## INDIANA DEPARTMENT OF TRANSPORTATION

### STANDARDS COMMITTEE MEETING MINUTES

RE: Revised Minutes for the November 16, 2006 Standards Committee Meeting

REVISION TO 2006 STANDARD SPECIFICATIONS

INDIANA DEPARTMENT OF TRANSPORTATION	
TEMPORARY CHECK DAM, STRAW BALES	
MARCH 2005	
STANDARD DRAWING NO. E 205-TECD-02	
DESIGNED BY L. J. ROBERTS NO. 9750	CHECKED BY L. J. ROBERTS DATE
DRAWN BY L. J. ROBERTS DATE	GROUP ENGINEER DATE

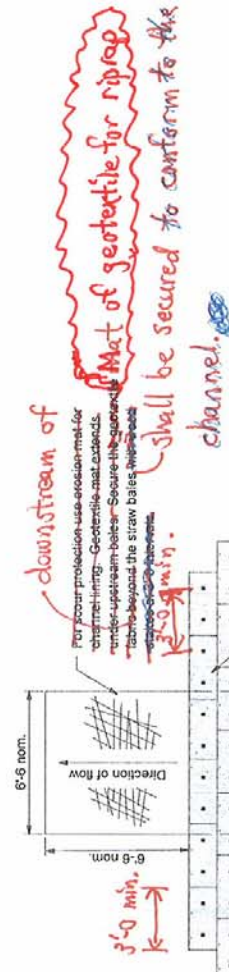
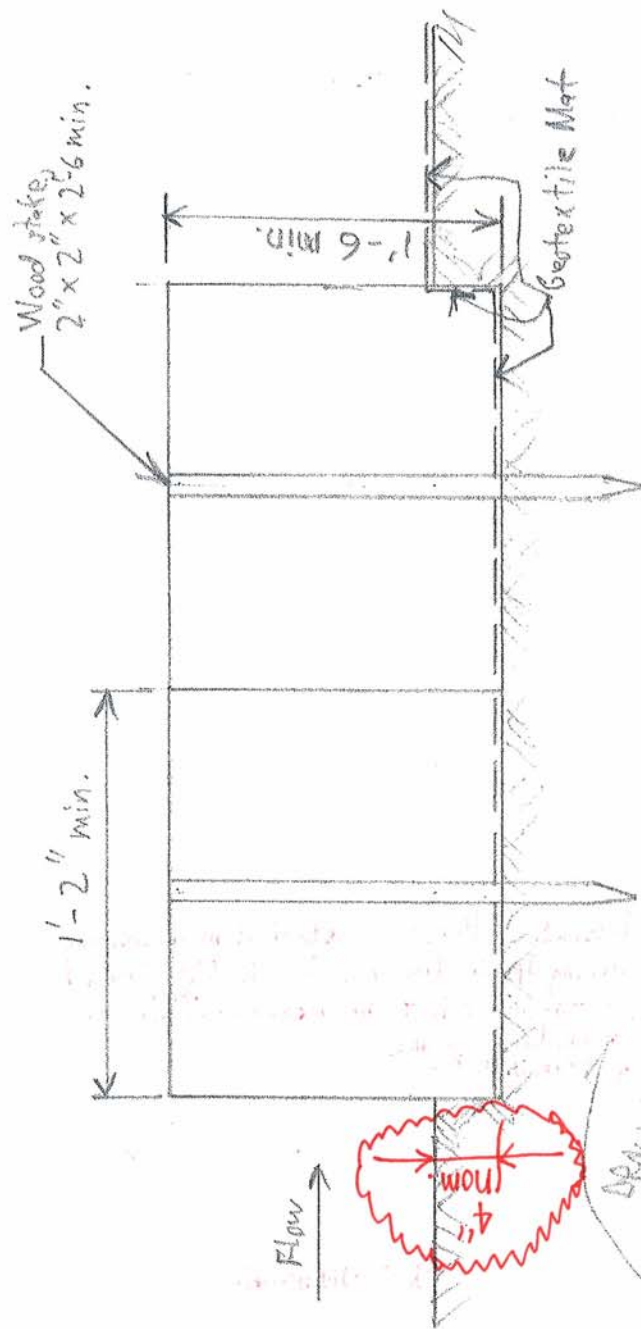
REPLACE WITH SIDE ELEV. VIEW

DRAW ANGLE  
SUCH THAT  
1'-2" DIMEN.  
APPEARS SHORTER  
THAN 1'-6" DIMEN.
